Bureau of Parks and Lands

Flagstaff Region Management Plan
5-Year Review and Update
with
Plan Amendments

June 26, 2014

AMENDMENT ADOPTION

Figure 1.

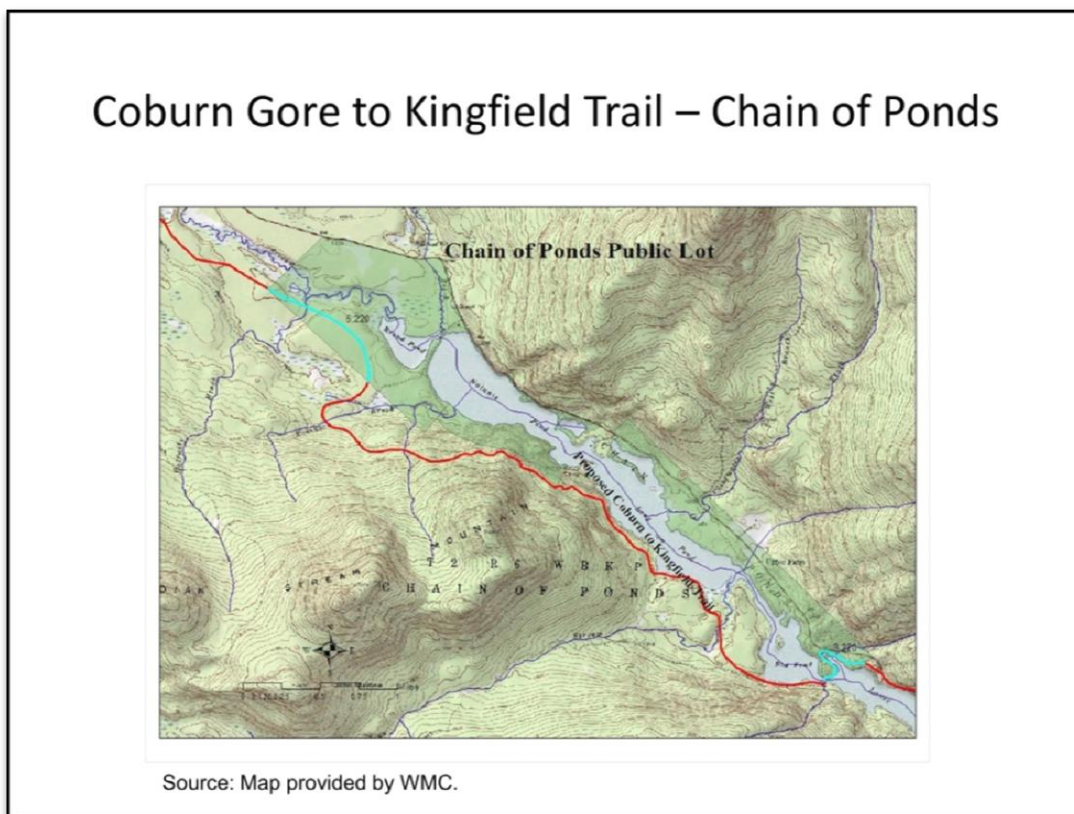
Coburn Gore to Kingfield Trail – Chain of Ponds area (Figure 1)

- Western Mountain Corporation proposal (part of proposed 47 mile trail)
- 1 mile and 0.6 mile segments of new multiuse non-motorized trail at north and south ends of the unit, 2 new bridges and “engineered boardwalk”
- *BPL Recommendation: Allow construction of trail segments and bridges, under certain conditions and requirements*

Amendment A: Coburn Gore to Kingfield Trail – Chain of Ponds Unit

Allow construction of trail segments and bridges proposed by Western Mountains Corporation (WMC) within the northwest and southeast portions of the Chain of Ponds unit, as part of the proposed 47-mile Coburn Gore to Kingfield multi-use non-motorized recreation trail, with the following requirements for final approval:

- 1) BPL approval of final trail route, with the northern segment traversing approximately 1 mile and the southern segment approximately 0.6 mile of BPL lands,
- 2) BPL approval of design and construction methods of any bridges and engineered boardwalks required to implement the approved route; and evidence of necessary regulatory permit approvals,
- 3) Evidence of approvals from abutting landowner(s) for a trail segment west of the unit linking the trail segments on BPL property.
- 4) Satisfactory resolution of any potential conflicts with state-sanctioned regional ATV trails near the north end of the unit and near Coburn Gore, where the proposed trail intersects the ATV trails, and
- 5) Development of a long-term agreement between BPL and WMC for maintenance of trail.

Figure 2.

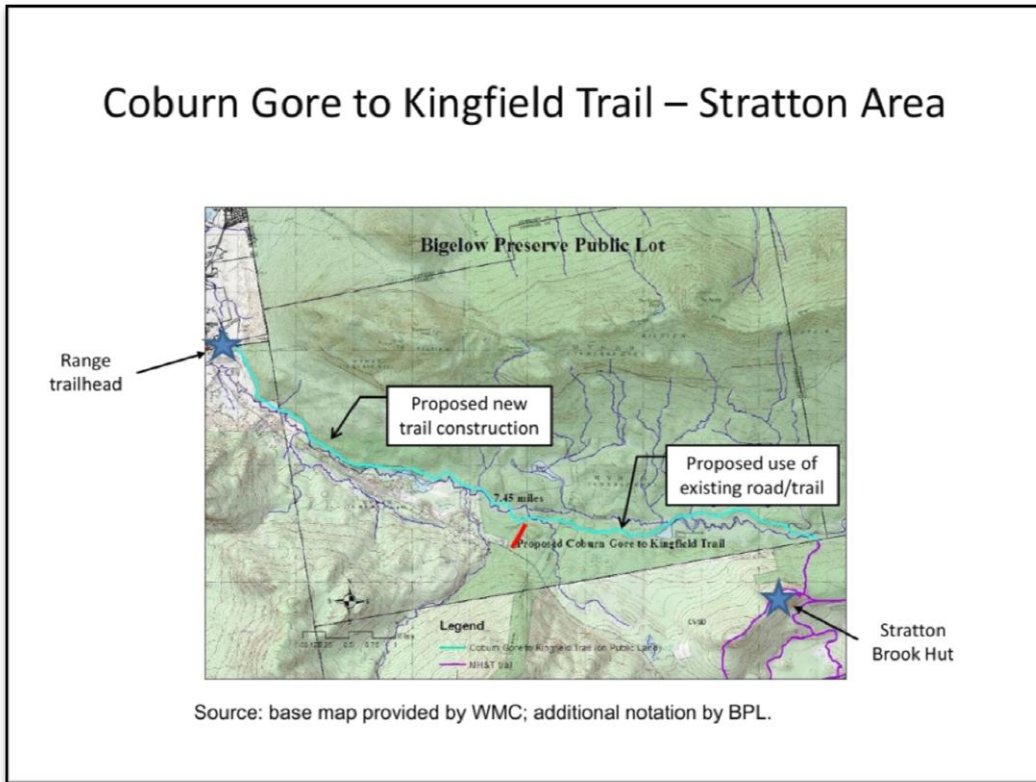
Coburn Gore to Kingfield Trail – Bigelow Preserve (Figure 2)

- Western Mountain Corporation proposal (part of proposed 47 mile trail)
- ~4.5 miles of new trail along Stratton Brook, ~3 miles on existing public access and management roads/trails
- *BPL Recommendation: Allow routing of trail and potential limited improvements on existing management and public use roads and trails*

Amendment B: Coburn Gore to Kingfield Trail - Bigelow Preserve

Allow the segment of the Coburn Gore to Kingfield non-motorized multi-use trail proposed to cross the Bigelow Preserve to be co-located with the existing management road and designated snowmobile trail between the Range trailhead and Stratton Brook Road, connecting to and following Stratton Brook Road and the existing bike and ski trail on the “60s management road.” The trail must be maintained with non-motorized equipment. BPL will consider trail improvements on the segment between the Range trailhead and Stratton Brook Road to facilitate bike and pedestrian use; any improvements must be compatible with snowmobile use. The trail concept is to be coordinated with other trail proposals (e.g., Maine Huts and Trails’ Stratton Brook Hut connector trail, CR-NEMBA’s proposed mountain bike usage of Bigelow Preserve management roads) to avoid incompatibilities.

Mountain Bike Trail Requests - Bigelow Preserve (Figures 3-7)

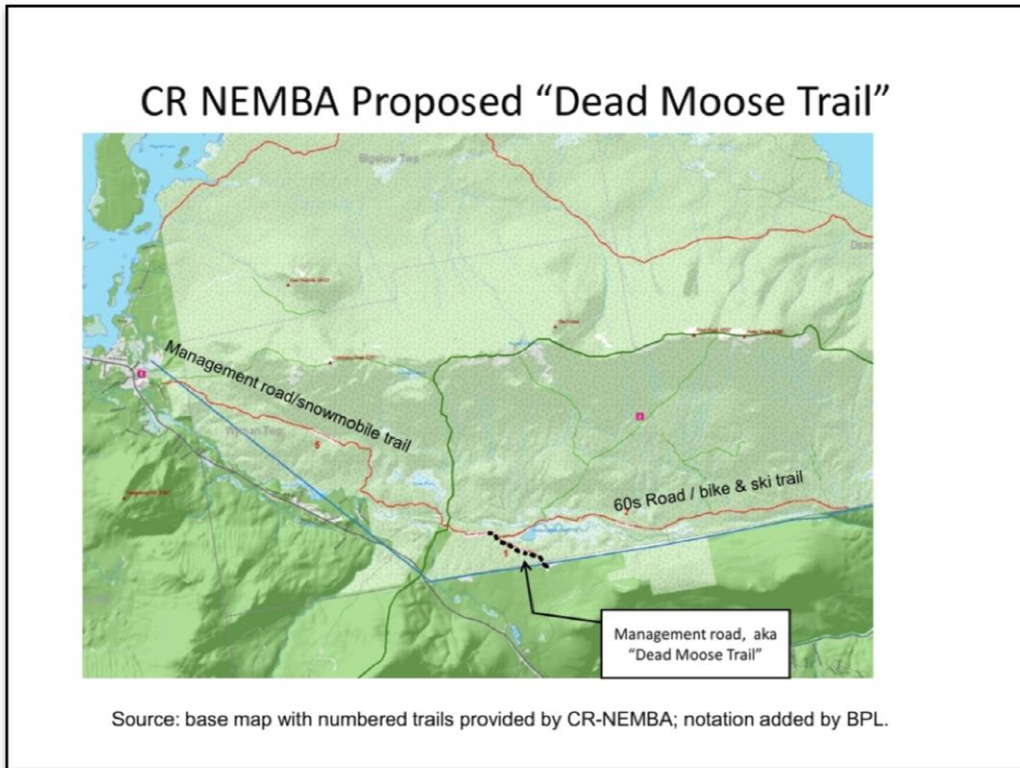
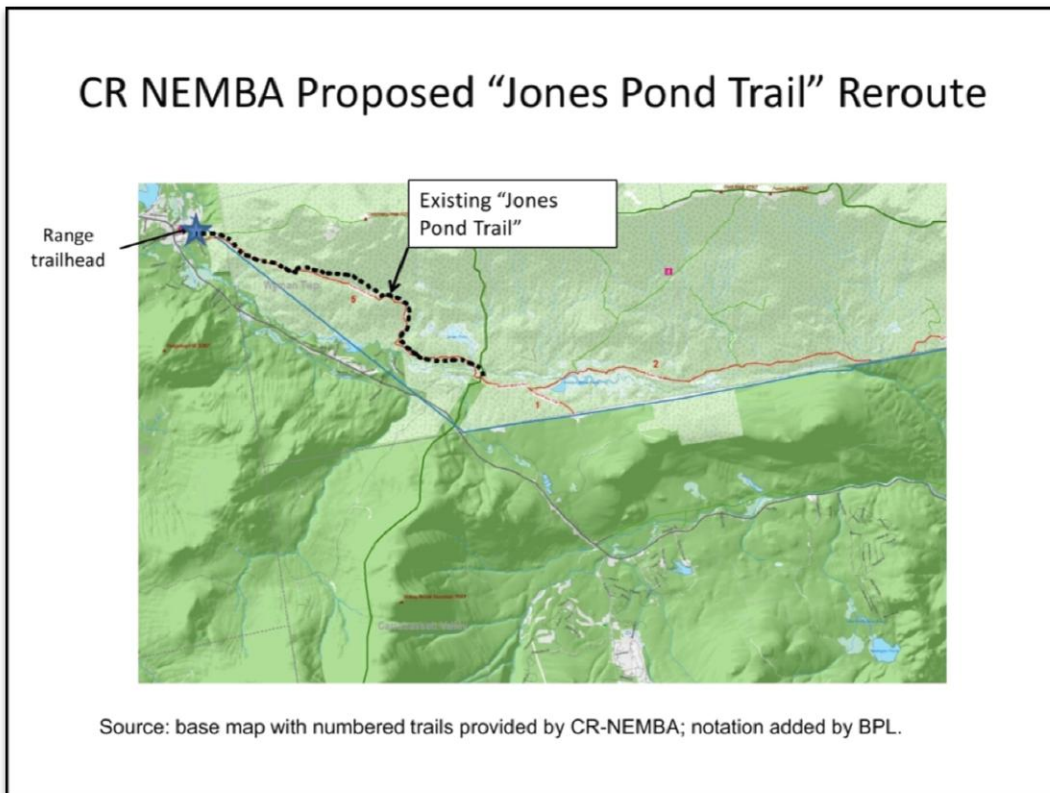
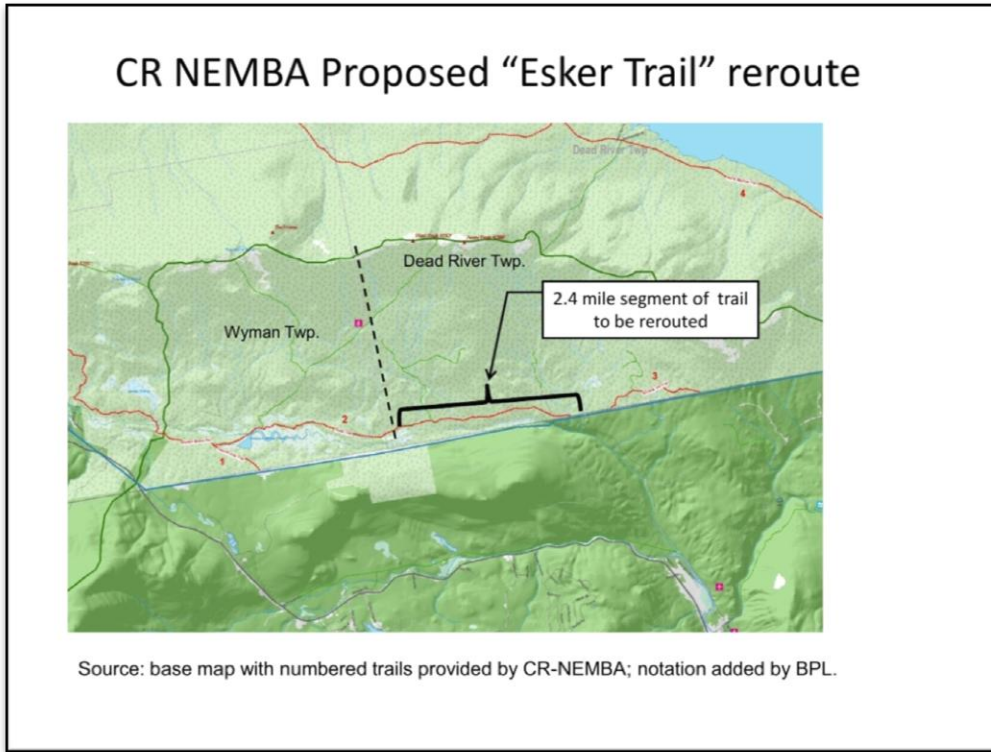
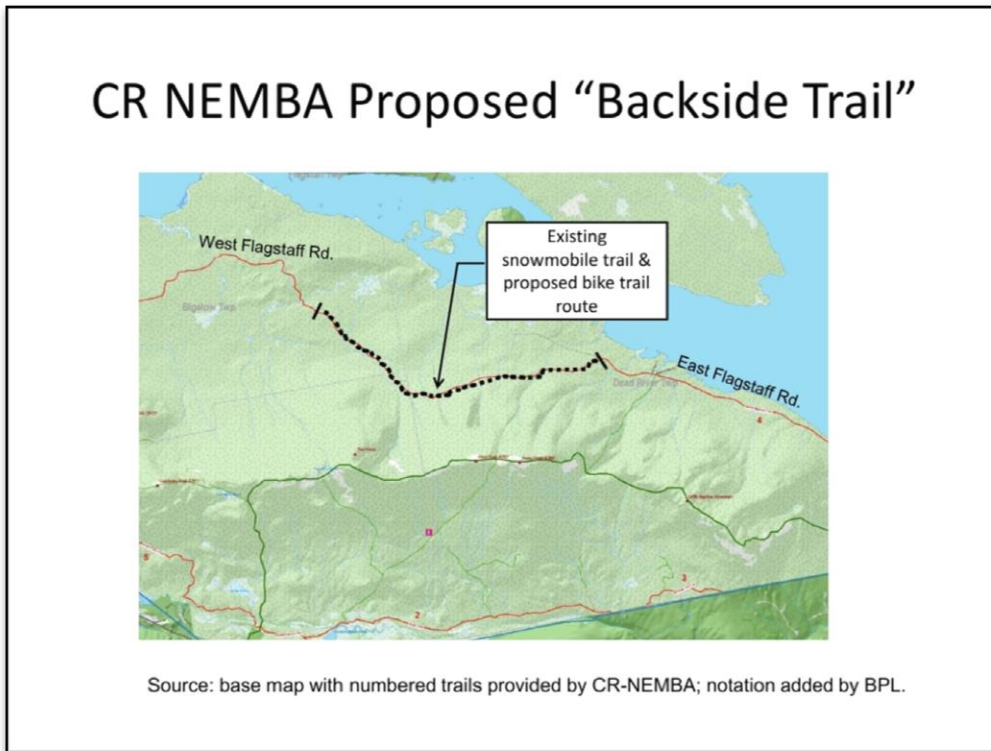
- 5 proposals from Carrabassett Region NEMBA
- 2 short management roads to be opened to mountain bikes
- Reroutes of 2 trails on management roads
- Opening of northern Bigelow Preserve snowmobile trail to mtn. bikes
- *BPL Recommendations:*
 - *Allow use of mountain bikes on 2 management roads*
 - *Allow minor reroutes of trail in problem areas on one management road*
 - *Allow up to 2.4 miles of new single-track trail parallel to existing trail as reroute around road scheduled to be upgraded and used for timber hauling*
 - *Proposal for new mountain bike route across northern Bigelow Preserve not allowed*

Amendment C: Mountain Bike Routes - Additions and Improvements

(1) Add two short management roads to the public use and management roads designated for mountain bike use (page 126 of Plan), to provide connections to the bike touring network on abutting lands.

Road 1 – 0.7 miles in length, within Wyman Twp., extending southeast from the Stratton Brook parking area to the CMP powerline corridor at the south boundary of the preserve.

Road 2 – 1.5 miles in length, within Dead River Twp., roughly parallel to the south boundary of the Bigelow Preserve/Carrabassett Valley line east of Huston Brook Road, connecting at each end to the CMP powerline corridor.

(2) Work with CR NEMBA to plan improvements on the existing management road/snowmobile trail between the Range trailhead and Stratton Brook Road to facilitate bike use and improve the riding experience, with the potential for limited reroutes in problem areas.

Amendment D: New Mountain Bike Single-Track Trail

Collaborate with CR NEMBA on a specific route and design for ~2.4 miles of rerouted trail focused on the Dead River Twp. portion of the Stratton Brook bike and ski trail (aka “60’s Road/Esker Trail”). The Bureau intends to reopen the 60’s Haul Road for timber harvesting in the near future. This rerouted trail will create a permanent “single track” trail along the popular section now utilizing the “60’s Road.” This is an important section of trail as it connects to a major network of mountain biking trails on lands adjacent to the Preserve. If the beaver flowage a half mile east of township/county line is not avoided by the reroute, consider improving the crossing to facilitate trail use during occasional flooding.

Figure 8.

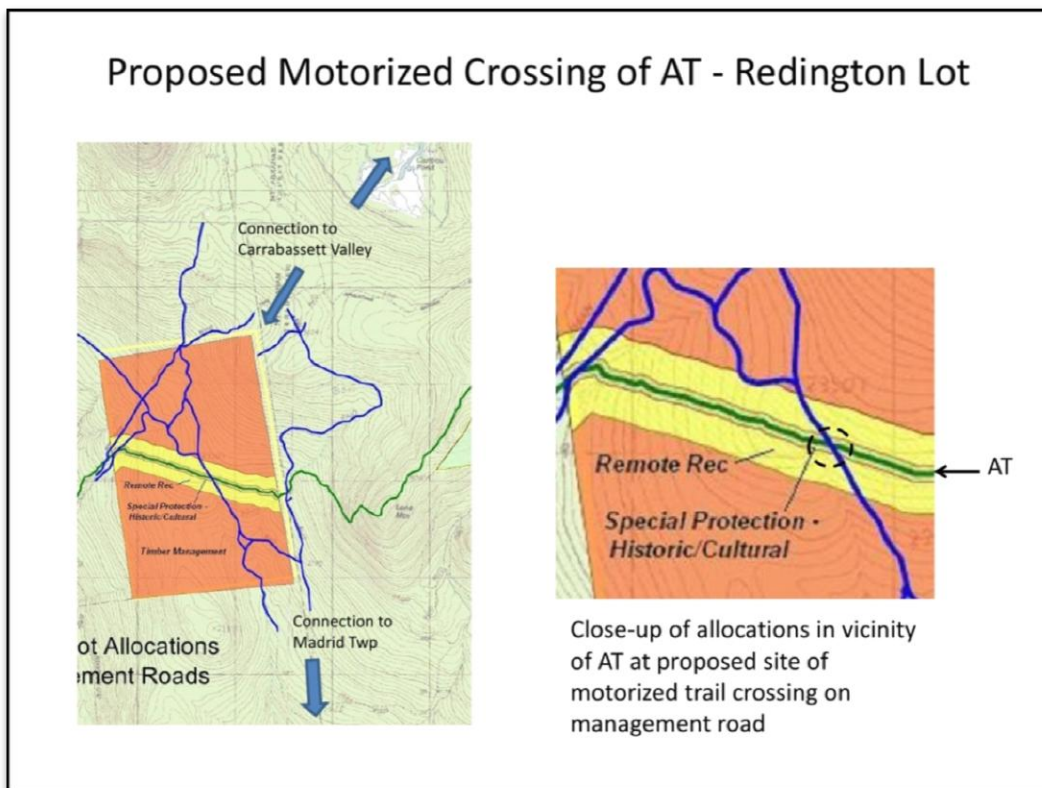
New Hiking/Ungroomed skiing trail – Carrabassett Valley Lot and Bigelow Preserve (Figure 8)

- Maine Huts & Trails proposal to connect hut to Bigelow Preserve trails
- 1.5 mile trail across Carrabassett Valley lot and following an old road into the Bigelow Preserve; footbridge would be required for safe crossing of Stratton Brook
- *BPL Recommendation: Allow construction of trail and bridge, under certain conditions and requirements*

Amendment E: Hiking/Snowshoeing Connector on Carrabassett Valley Lot and Bigelow Preserve to Link Maine Huts and Trails Stratton Brook Hut to 60’s Haul Road

Allow construction of a new hiking/snowshoeing/ungroomed ski trail by Maine Huts & Trails (MH&T) between an existing multi-use non-motorized trail near the Stratton Brook Hut and the 60’s Road bike/ski trail. The trail will cross the Carrabassett Valley lot and enter the Bigelow Preserve on an old road at a crossing of Stratton Brook. The total trail length will be approximately 1.5 miles; approximately 1,200 feet of the trail will be within the Bigelow Preserve, north from Stratton Brook to the intersection of the old road with the 60’s Road. The final route of the trail on the Carrabassett Valley Lot is to be determined by BPL in collaboration with MH&T. Construction details for the trail, addressing drainage and potential erosion issues, must be approved in advance of construction by BPL. The design and construction methods for a pedestrian bridge over Stratton Brook are to be developed by MH&T and approved by BPL. (Mechanical equipment would not be permitted for trail or bridge construction north of Stratton Brook). The trail is to be posted with appropriate signage as closed to bicycles, and indicated as such on BPL and MH&T maps. Trail planning will seek to minimize potential conflicts with the
